TRANS/WP.29/GRE/2002/12  
25 January 2002

World Forum for Harmonization of Vehicle Regulations (WP.29)

PROPOSAL FOR DRAFT CORRIGENDUM 1 TO REGULATION No. 112

(Headlamps emitting an asymmetrical passing beam)

Figure C  
Primary Driving Beam

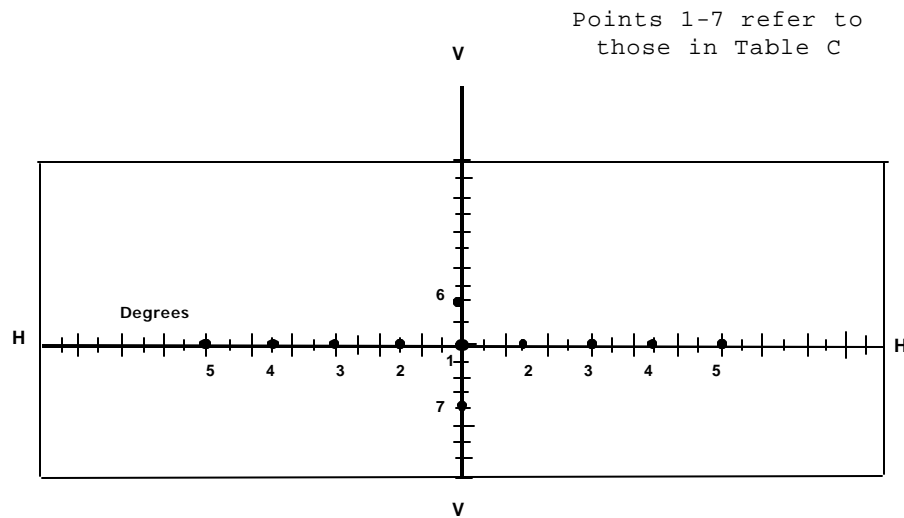
Annex 3, insert at the end Tables C and D and Figures C and D, to read as follows: 1/

Refer to Figure C for details of test point positions

1/ Note by the secretariat: Figure C already exists in the current text of the Regulation and shows the measuring points for right-hand traffic. Should new Figure C replace it, or should new Figure C (and Table C?) be renamed?

Figure D  
Secondary Driving Beam

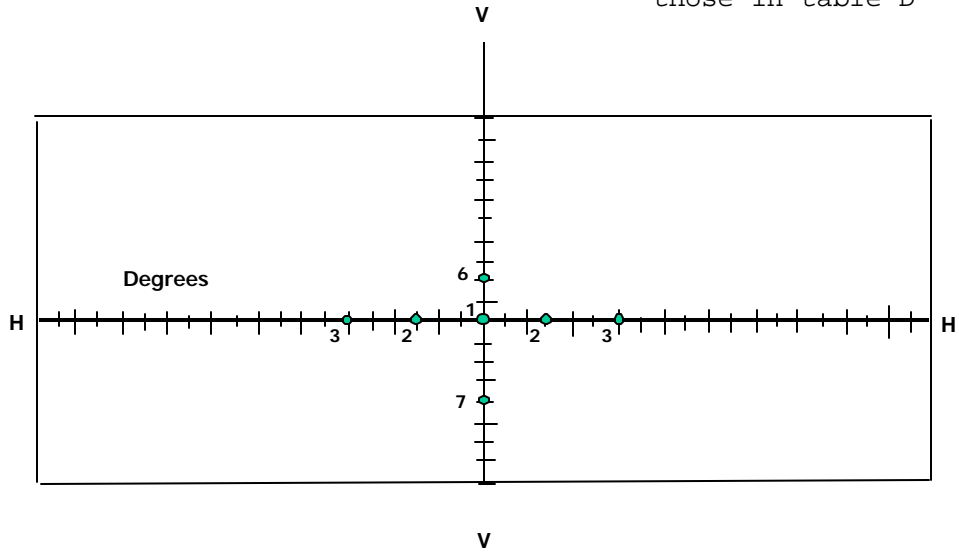
Refer to Figure D for details of test point positions

Points 1-7 refer to  
those in table D
